AGENDA

MATANUSKA-SUSITNA BOROUGH

PLATTING BOARD MEETING **1:00 P.M.** **April 2, 2026**

A. **HOUSTON RAIL NW:** The request is to create 5 lots and dedicate the portions encumbered by the W. Parks Highway as right of way from Tax Parcels A6, D4, & C8, to be known as **HOUSTON RAIL NW SUBDIVISION**, containing 119.9 acres +/- . The property is located north of Little Susitna River, south of W Zero Lake Road, and fronts on W. Parks Highway (Tax ID #18N03W20A006, 18N03W20D004, & 18N03W21C008); within the E ½ Section 20 & the SW ¼ Section 21, Township 18 North, Range 03 West, Seward Meridian, Alaska. In the City of Houston and in Assembly District #7. (Petitioner/Owner: Matanuska-Susitna Borough, Staff: Matthew Goddard, Case # 2026-008)

PRELIMINARY PLAT

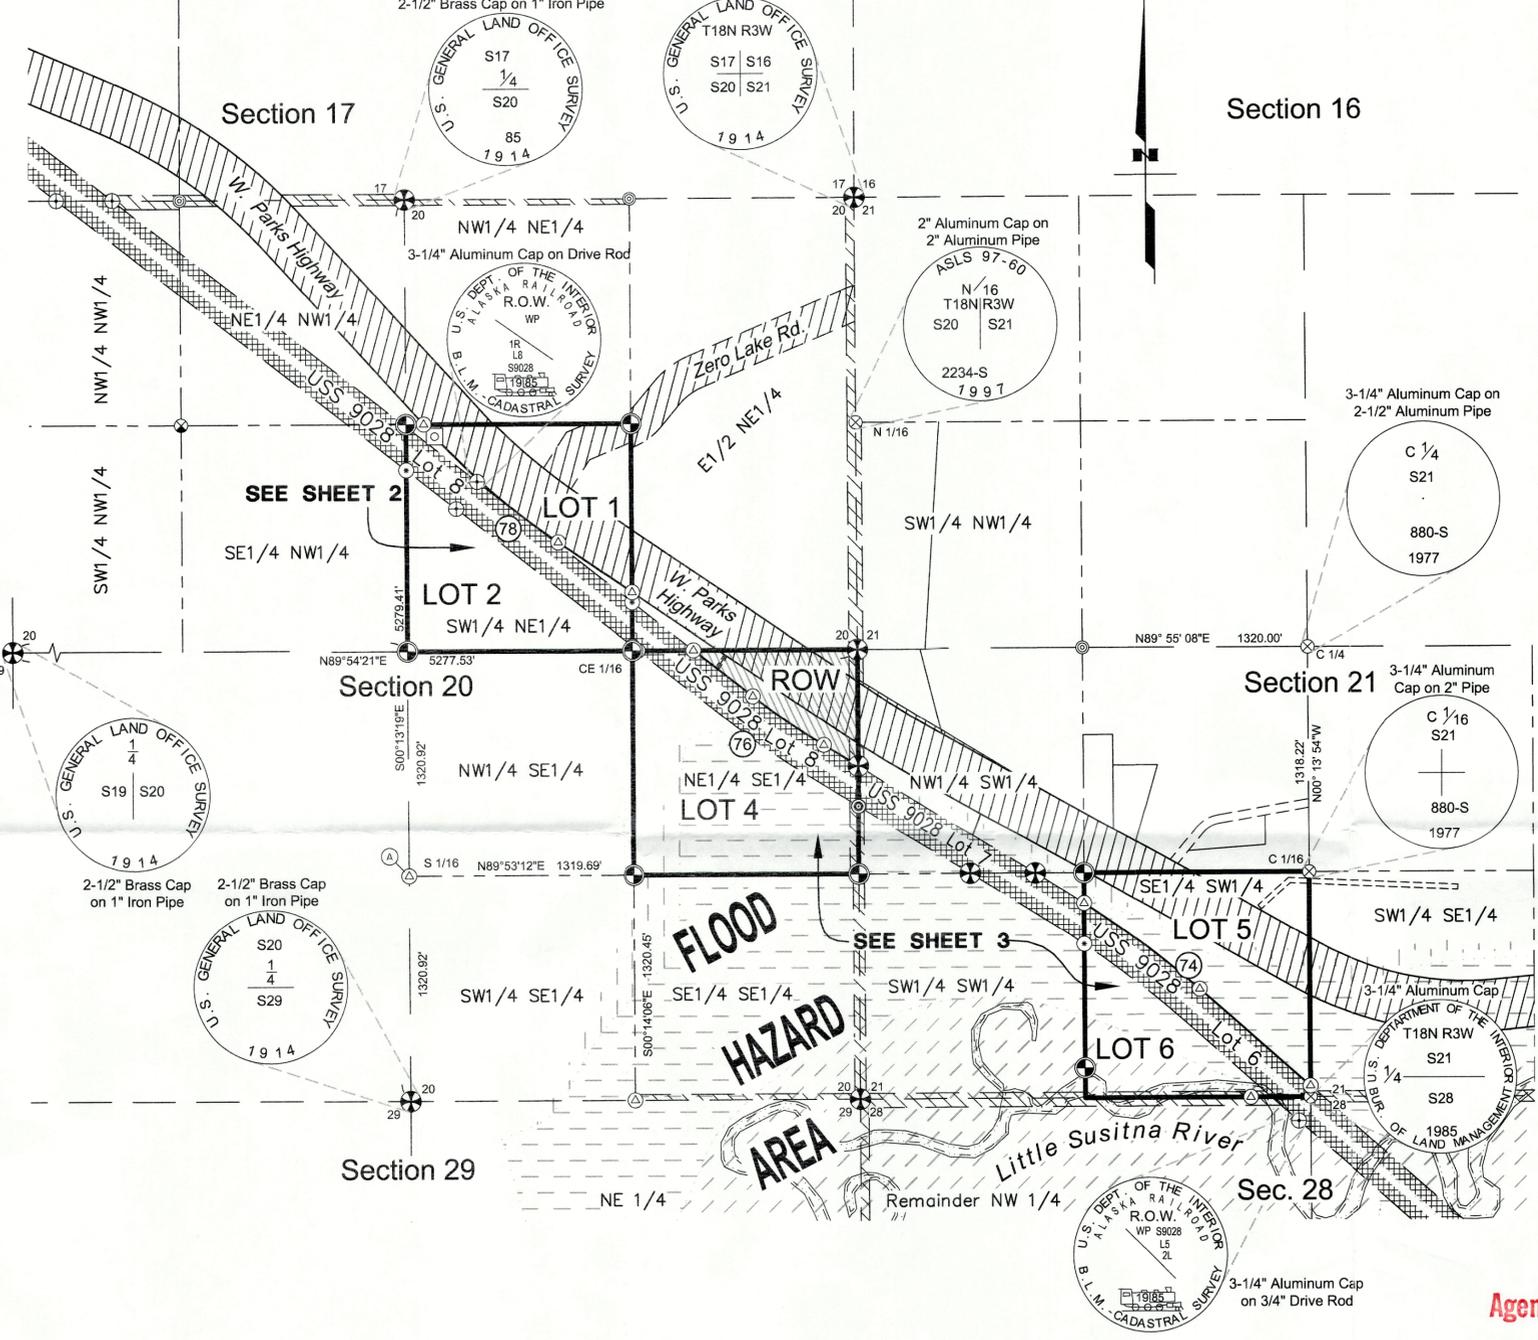
- Add a plat note referencing recorded document 2021-007028-0 and that all access for all lots to the Parks Highway has been determined by this document.
Staff notes the referenced document is not an easement and is subject to future change. As such, our code does not require this document to be shown on the plat.

Matanuska-Susitna Borough Land & Resource Management (MSB) respectfully requests that a plat note not be added to the *Houston Rail Northwest Subdivision* plat regarding the MSB and Alaska Department of Transportation & Public Facilities (DOT&PF) Parks Highway Access Development Permit, recorded under Serial Number 2021-007028-0 PRD.

Based on our understanding of MSB Title 43 (Subdivision Regulations), easements must be shown or noted on the plat; however, permits are not required to be added as plat notes. This approach ensures that plats remain accurate and stable over time, while permits—being subject to change—can be managed appropriately through the permitting agencies.

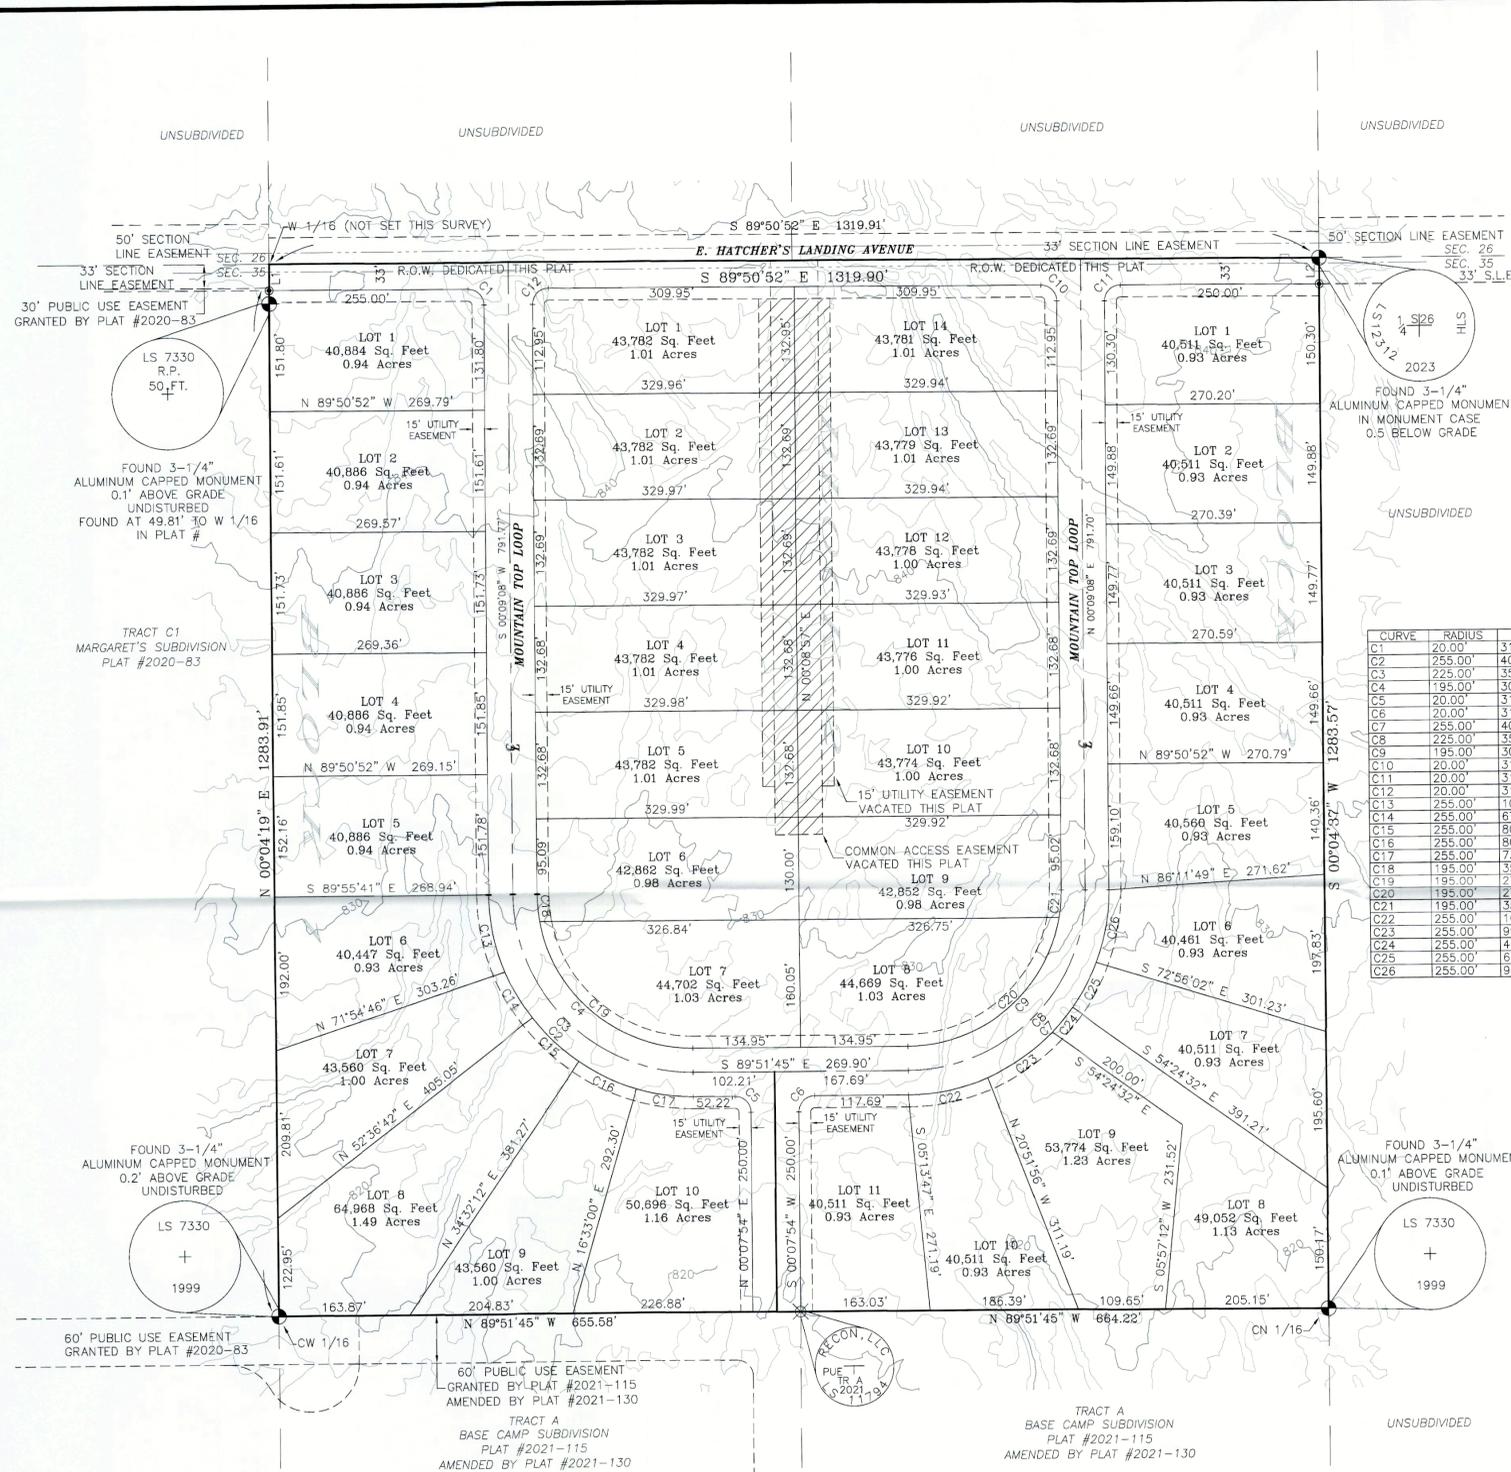
The summary states there will be 35 lots created to be known as Mountain Top Acres Additions 1; however the agenda plat calls out the lots (no block numbers) with there being 3 different Lot 1’s. Please clarify the lot numbers (or identify blocks).

The summary states there will be 35 lots created to be known as Mountain Top Acres Addition 1; however the agenda plat calls out the lots (no block numbers) with there being 3 different Lot 1's. please clarify the lot numbers (or identify blocks).

Staff notes that block numbers will need to be added during the final review process (Recommendation #5).

5. Add Block labels as appropriate.
6. Show all easements of record on final plat.
7. Submit recording fees, payable to Department of Natural Resources (DNR).
